# 1968 Corvette: Service Bulletin: Gas Line Rattle

**Source:** Chevrolet Dealer Service Information Bulletin - General Motors  
Canada

**Bulletin No:** 68-IC-54

**Date:** June 29, 1968

Fig. 1.

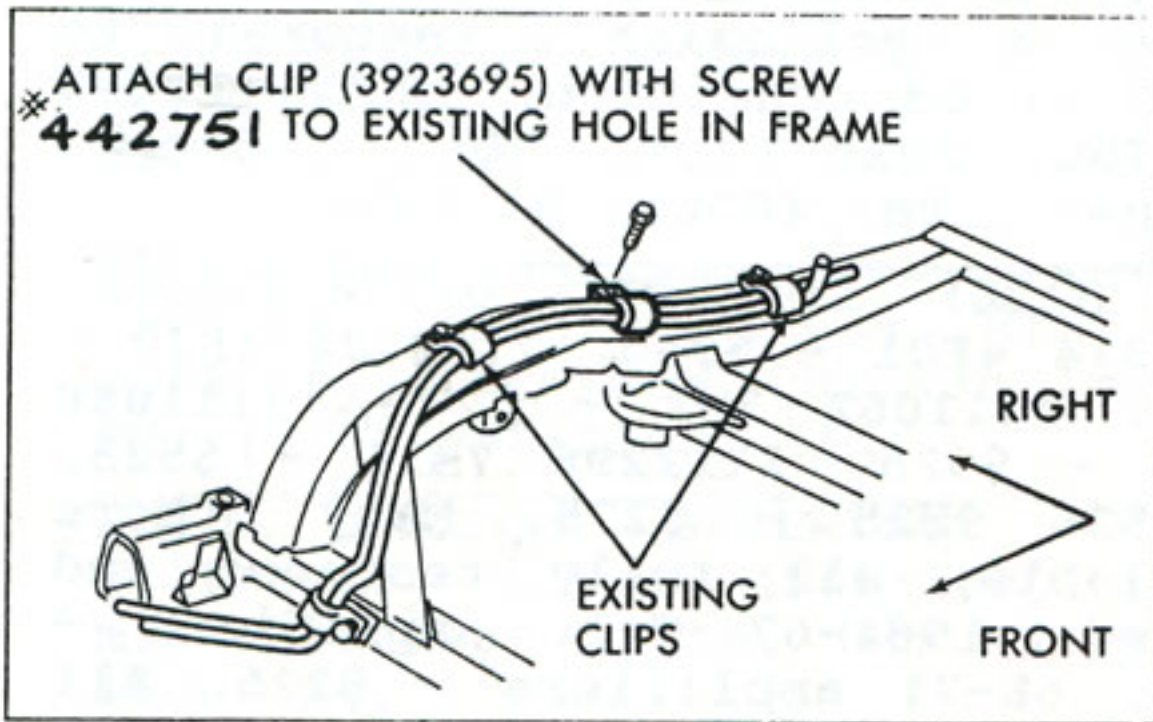
A rattling or "ticking" noise from the rear of the vehicle has been experienced on some 1968 Corvettes. This noise is resulting from the fuel supply line vibrating against the return line. Production has corrected this condition by installing an additional clip in the existing frame hole at this location. Refer to Fig. 1. This same correction is recommended for units in the Field that are experiencing the rattling or "ticking" noise. Fig. 1 illustrates where the clip should be added and gives the related parts data.
